**DATE OF THE BULLETIN:**

May 4<sup>th</sup>, 2020

**MODELS AFFECTED:**

Tank warping due to heat

Tank Support Kit #700-7015D

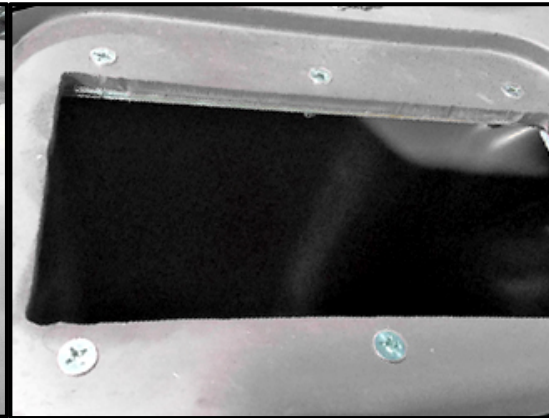
We are now installing a metal support bracket on our XR Recovery tanks to prevent warping in the field. Should a tank warp, please contact [warranty@rpscoperation.com](mailto:warranty@rpscoperation.com) and we will work with you to install XR Recovery Tank Support Kit - #700-7015D.
